**JFAC What Fits Activity - Part 1
Evaluation Summary - Buck Only**

Part 1 Scheme
5B

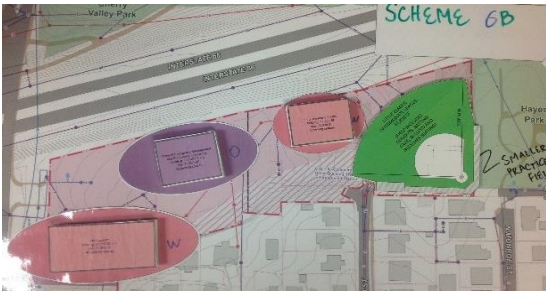
Diamond field doesn't fit with APS bus storage
Preferred diamond field orientation is SW (home) to NE (cei)

6B
North Side
Safety Campus
Redevelopment

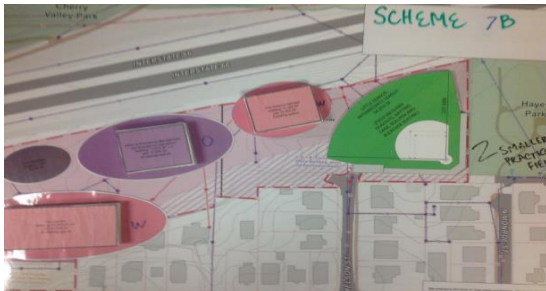
Moderate investment

Replace diamond with elementary rectangular field
Stack fire in new building at west end
Stack police in new building at east end
OEM in existing front office
Preferred diamond field orientation is SW (home) to NE (cei)

7B

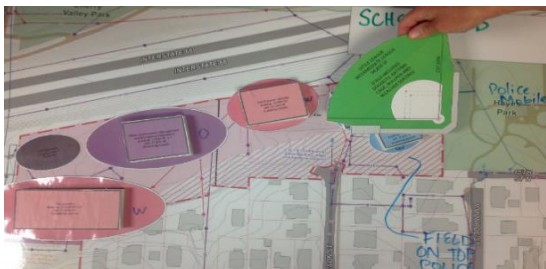
Difficult to access construction lay down
Diamond field doesn't maximize space
Preferred diamond field orientation is SW (home) to NE (cei)
